**PLANNING COMMISSION REPORT**  
**Regular Agenda -Public Hearing Item**

**ITEM NO. 1C      FINAL DEVELOPMENT PLAN FOR ALVAMAR LOT 1; 1809 BIRDIE WAY (SLD)**

**FDP-17-00028:** Consider a revised Final Development Plan for Alvamar Lot 1, located at 1809 Birdie Way for the addition of an 8,200 SF multi-purpose building. Submitted by Paul Werner Architects, for Eagle 1968 LC, property owner of record.

Figure 1: Alvamar PD and Expanded Area

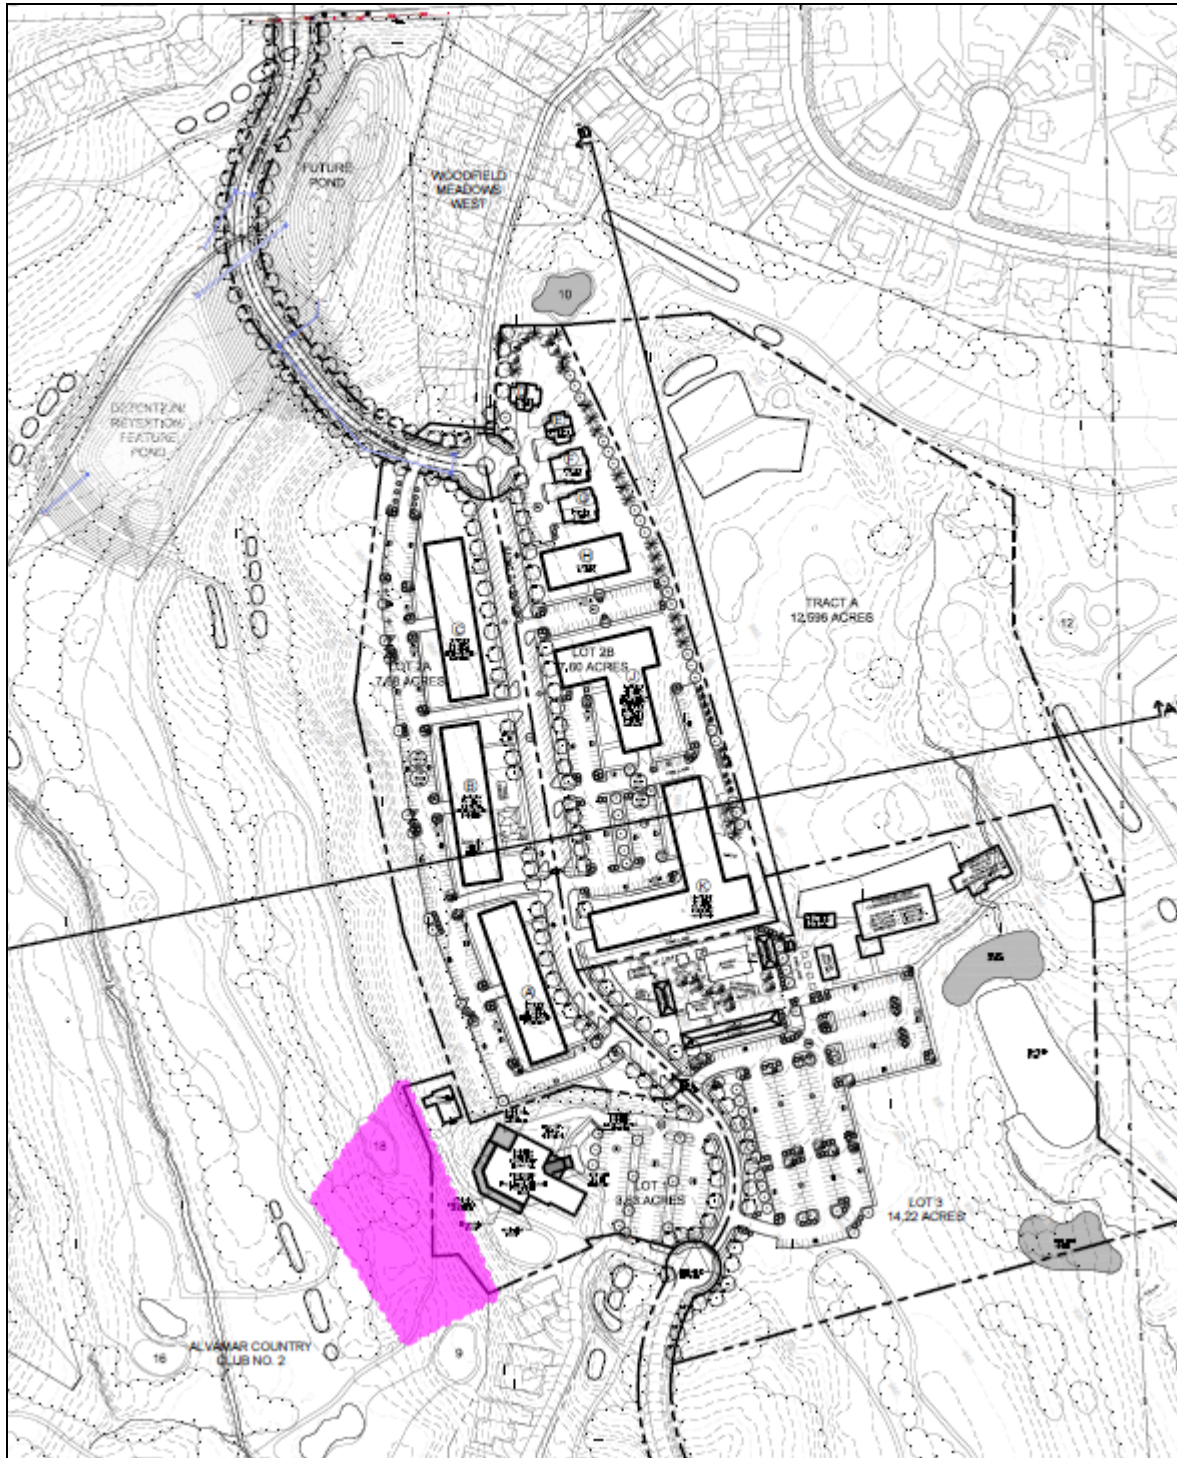
The following graphic highlights the location of the proposed change in relationship to the overall Alvamar PD development.
